AGENDA

President and Board of Trustees
Village of Arlington Heights
Board Room

November 20, 2017

File Number: PC# 17-010
Project Title: St. Edna's Catholic Church
Address: 2525 N. Arlington Heights Rd.
PIN: 03-17-101-019

DRAWN: _____	PLAT DATE: 05/01/2017
CHECKED: _____	
JOB NUMBER: 1020	C-4

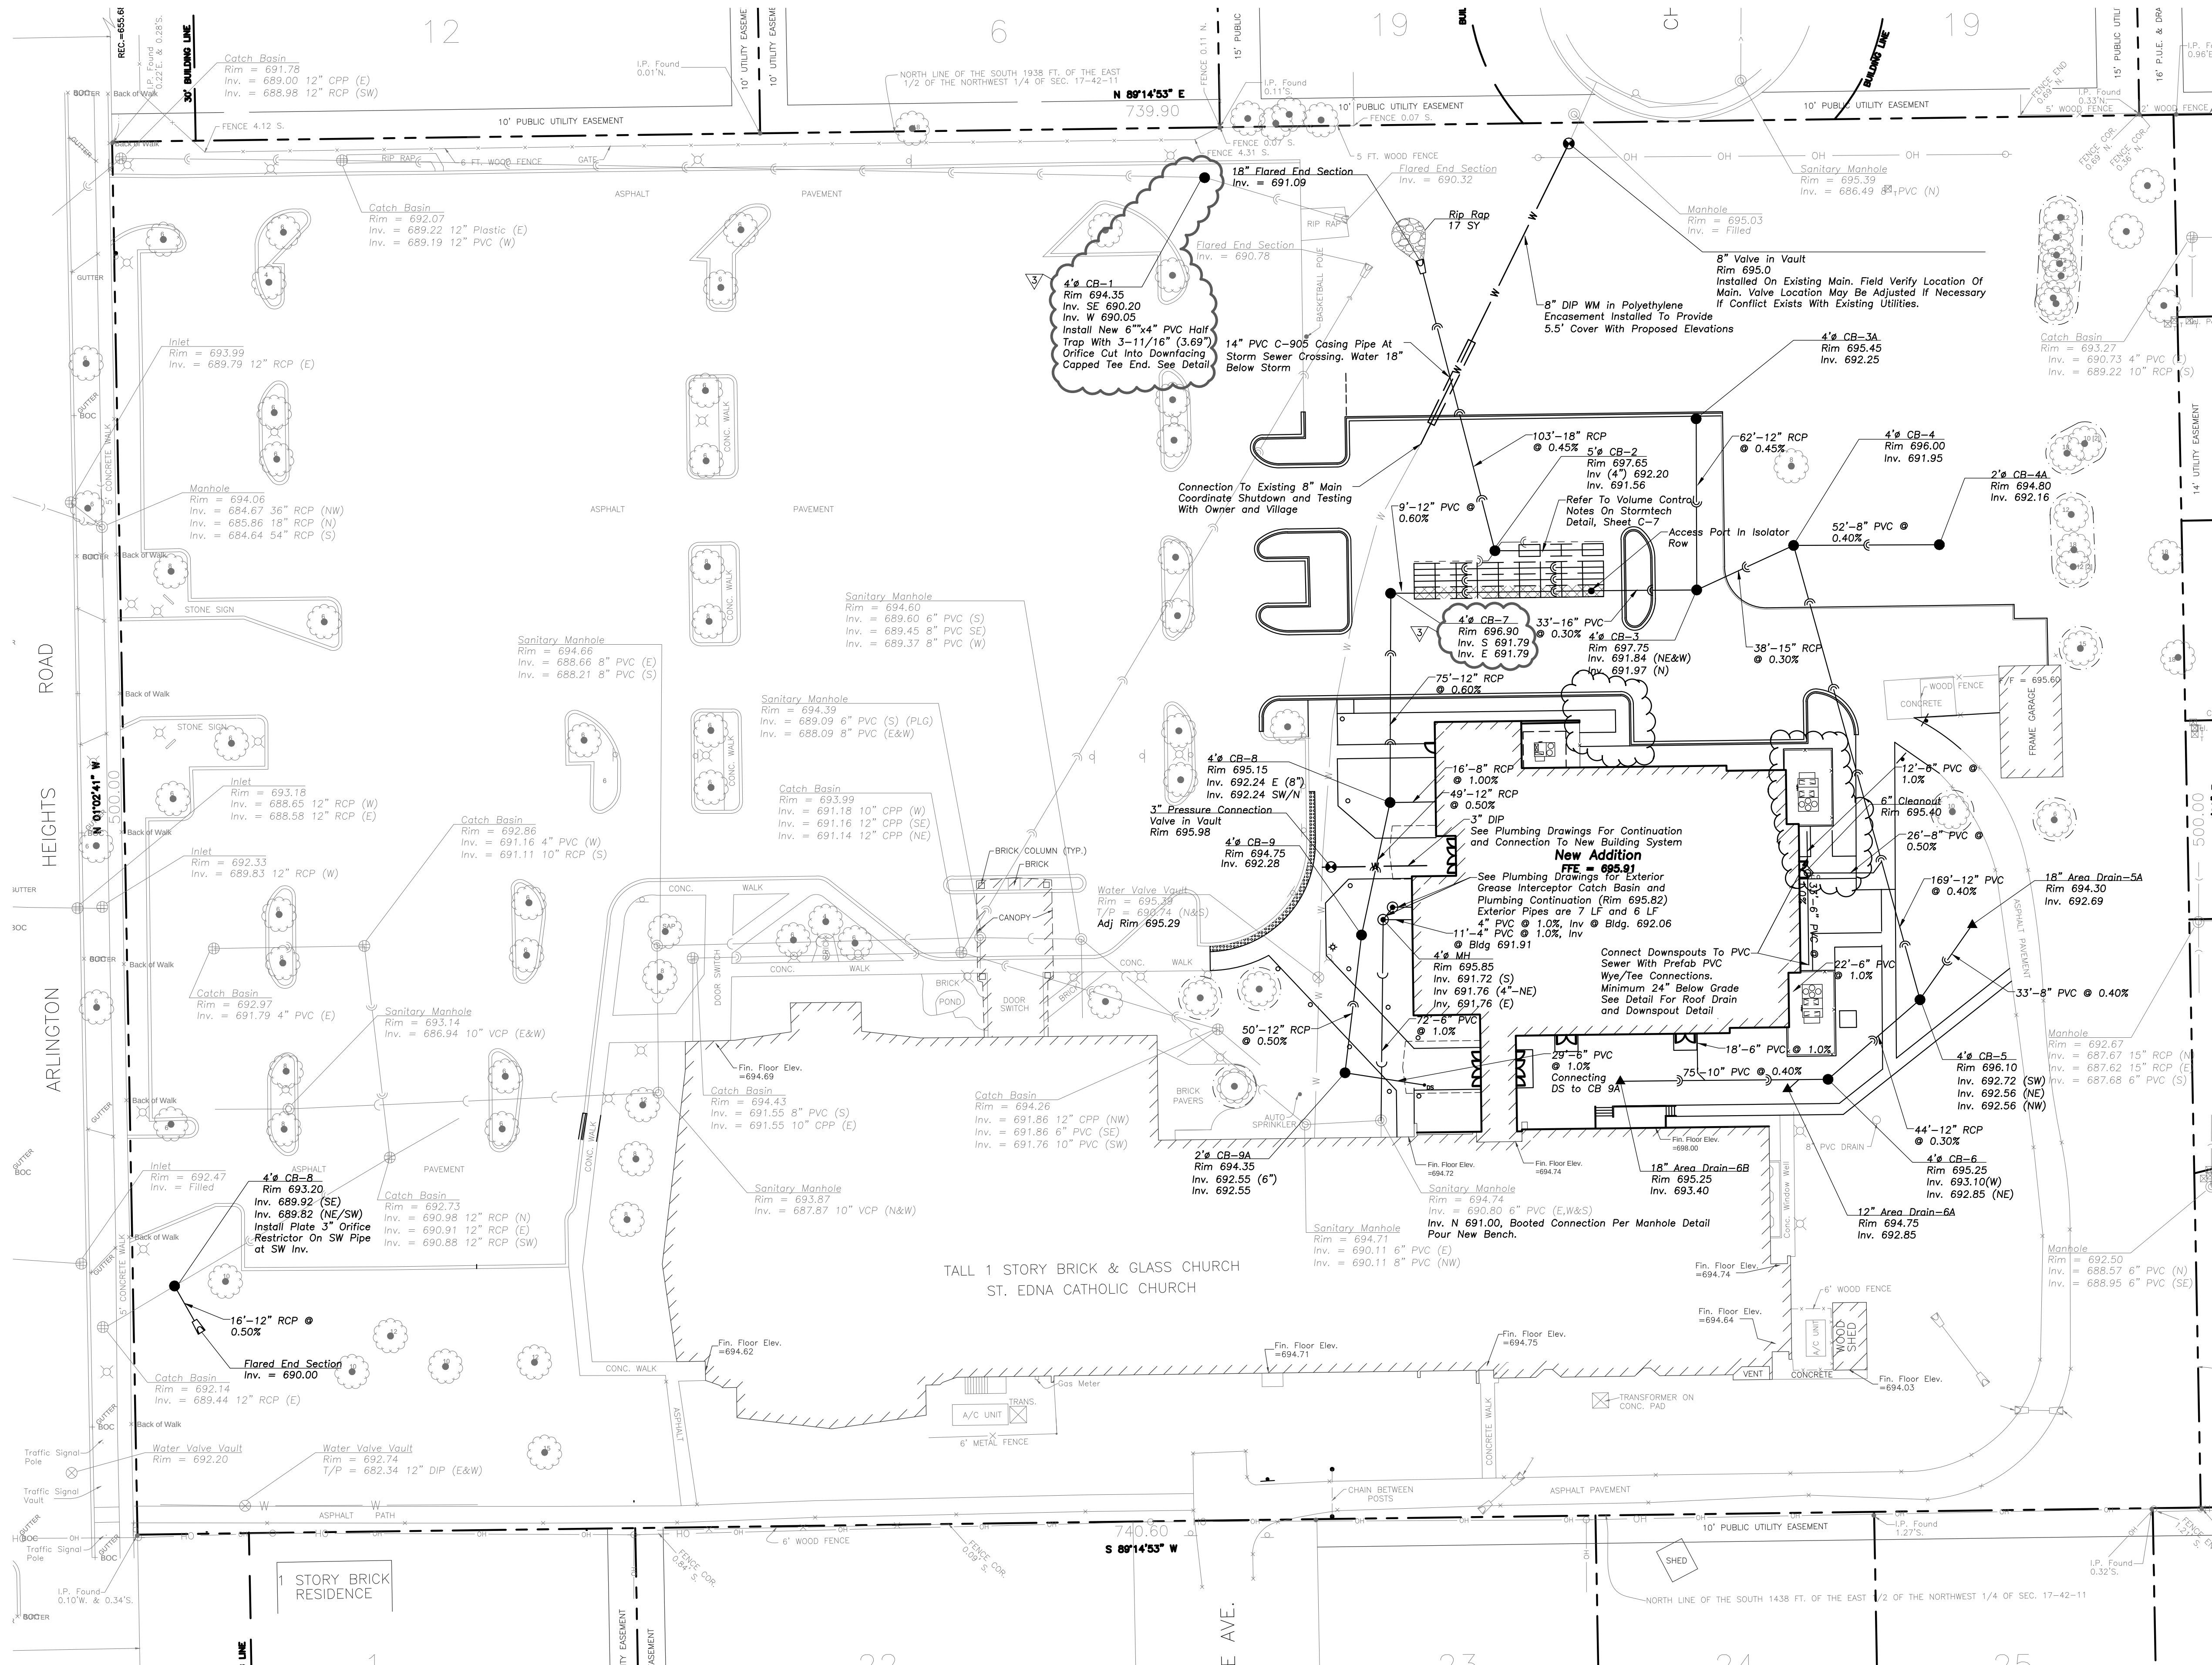
As stated, the detention will be designed to accommodate both Arlington Heights and MWRD requirements and all calculations will be provided prior to final approval. The existing plate restrictor will be removed and replaced with a half trap orifice restrictor. The existing manhole at that location will be replaced by a catch basin. The location and size of the restrictor and structure are shown on sheet C-4. A detail of the restrictor structure is on sheet C-6.

- 1) Illustrate on Civil Plan Sheet C-4 where the meter vault will be placed.
- 2) Provide a detail specific to the water meter vault.

LANDSCAPE PLAN		
DRAWN:	PLOT DATE:	
DRM	6/23/2017	
CHECKED:		
DRM		
JOB NUMBER:	L1.0	
1722

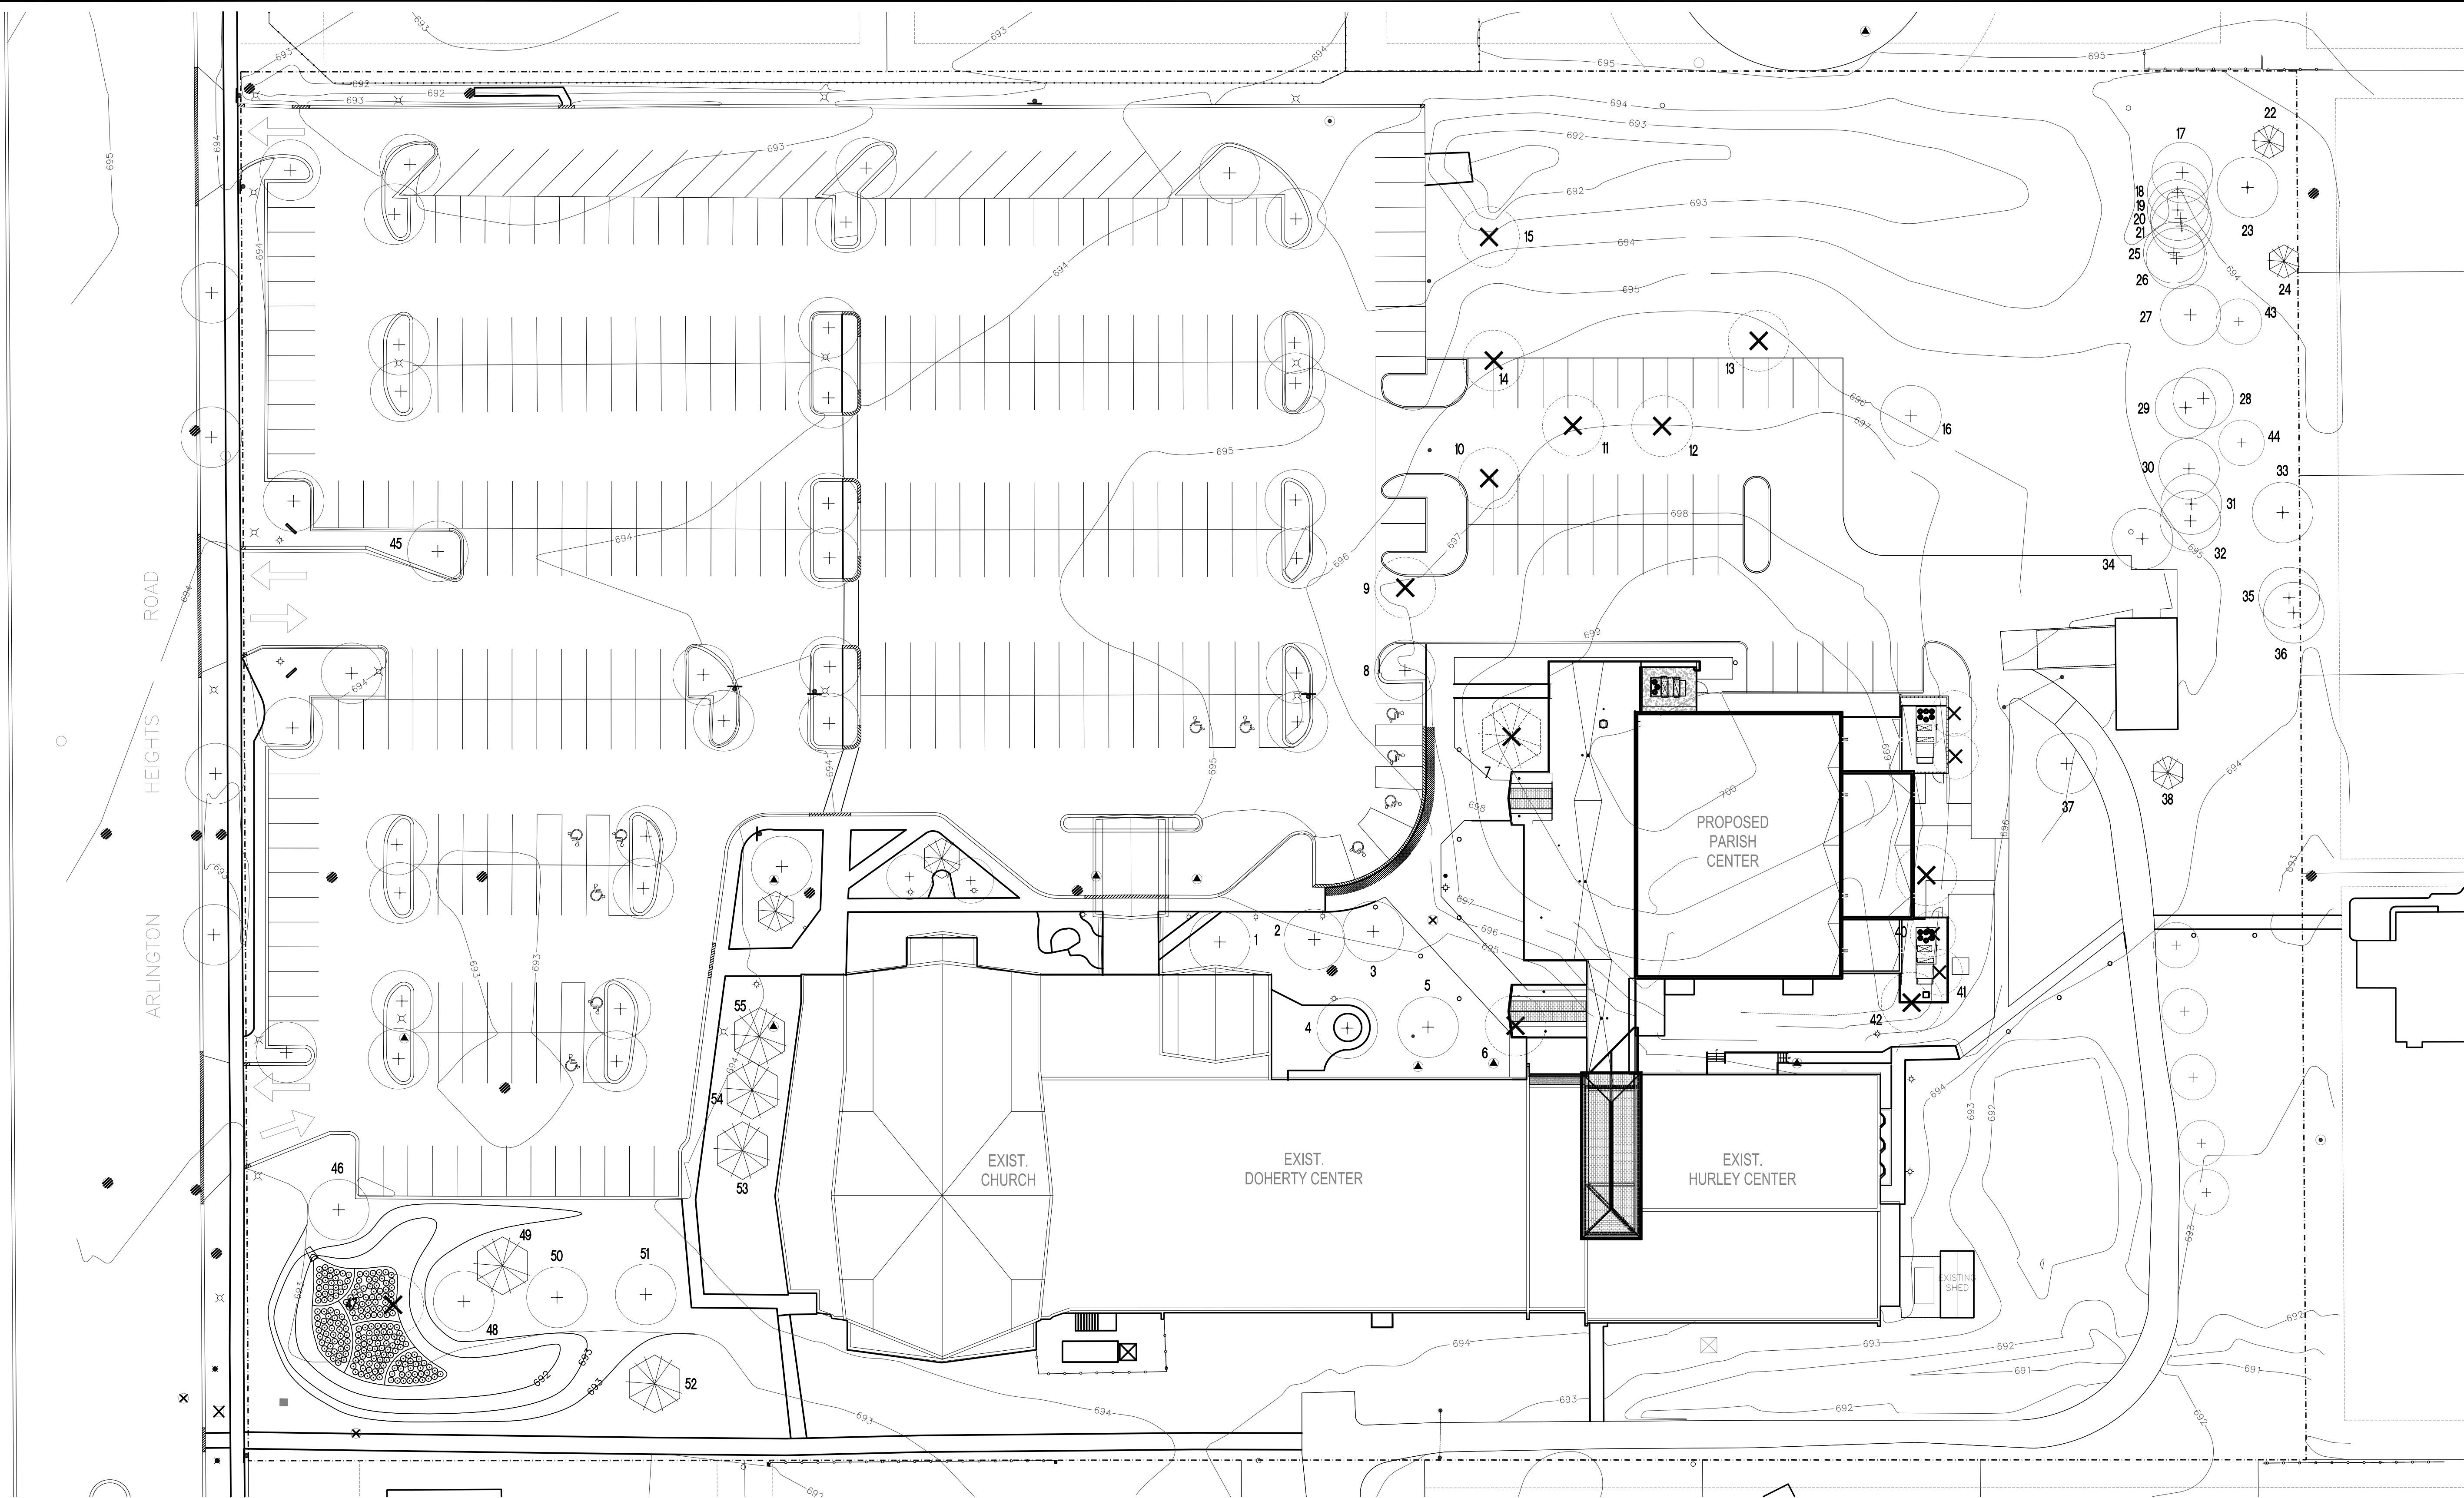
parking total from 45 spaces to 44. Please see the attached architectural site plan or the landscaping plan (L1.0).

Landscaping has been added to the east side of the proposed lot. Please refer to the attached landscape drawing L1.0 for proposed plant types.
